# Addendum No. Two

RFP No: FY24-805-45 A

Airport Terminal Building Improvements AWIP : BHS-TC2/TC4 : A-Wing Offices

This Addendum # 2 to Request for Bids for Airport Terminal Building Improvements AWIP : BHS-TC2/TC4 : A-Wing Offices contains the following responses to bidder inquiries and clarifications or changes to the Bid Documents:

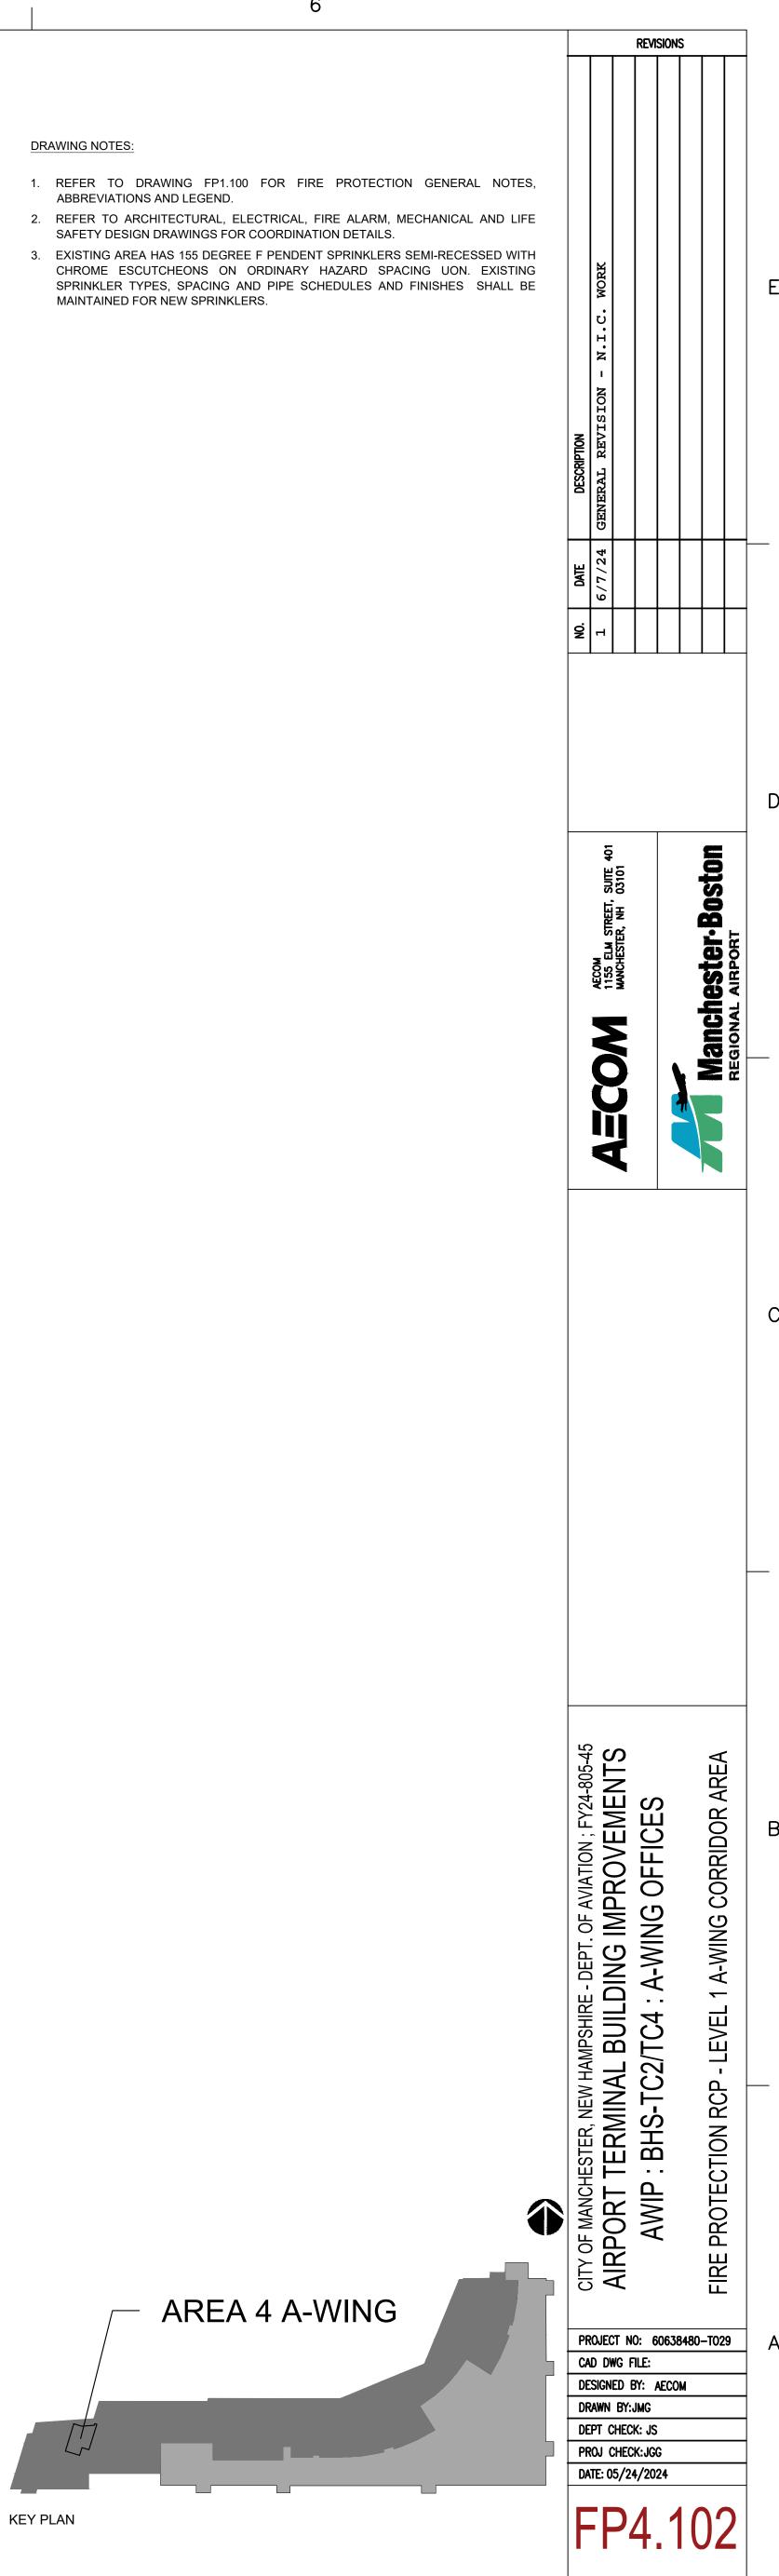
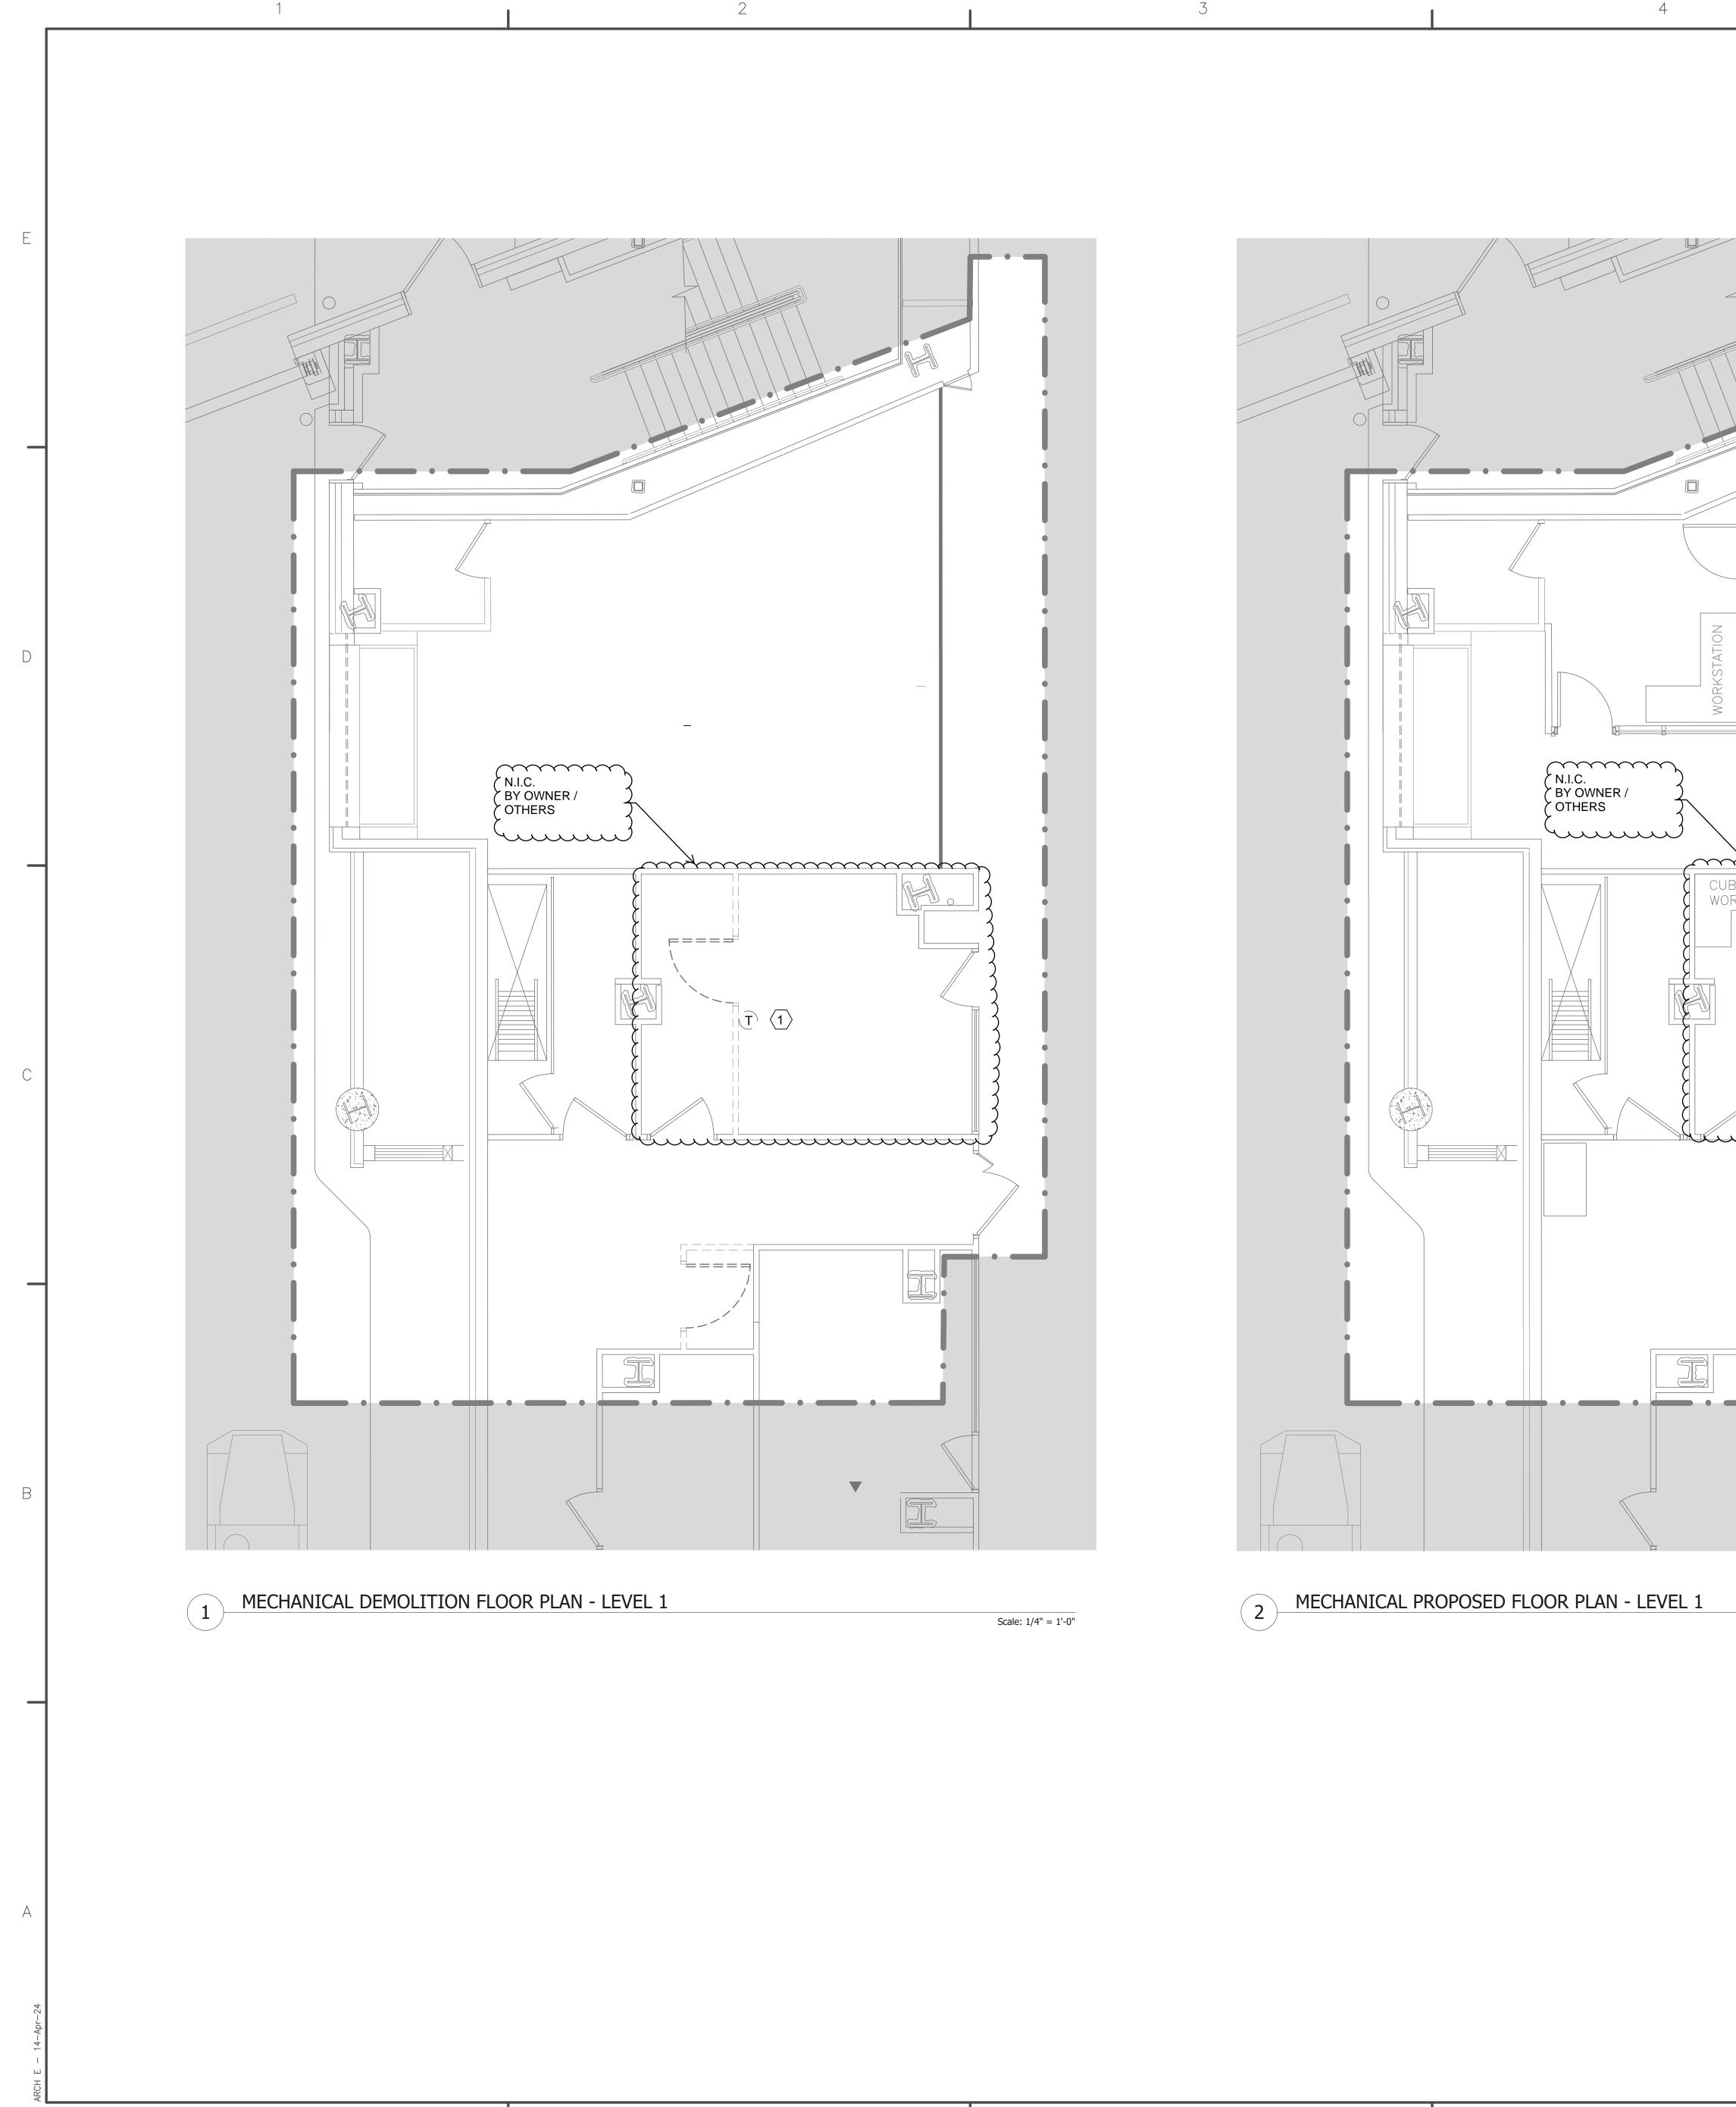
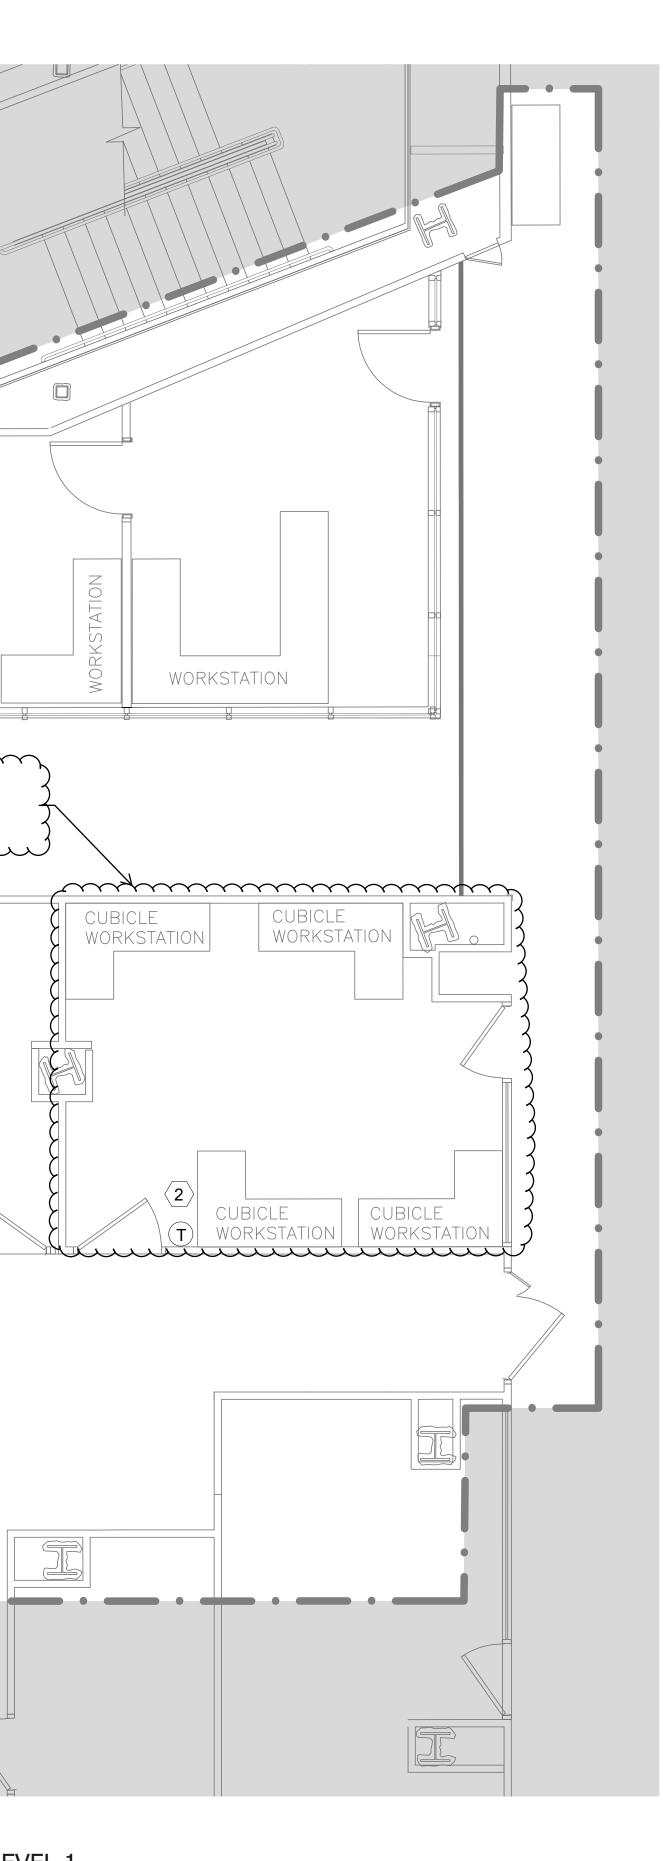
( 1. REPLACE CORRODED SPRINKLER WITH NEW CONCEALED SPRINKLER AND PROVIDE NEW COVER.
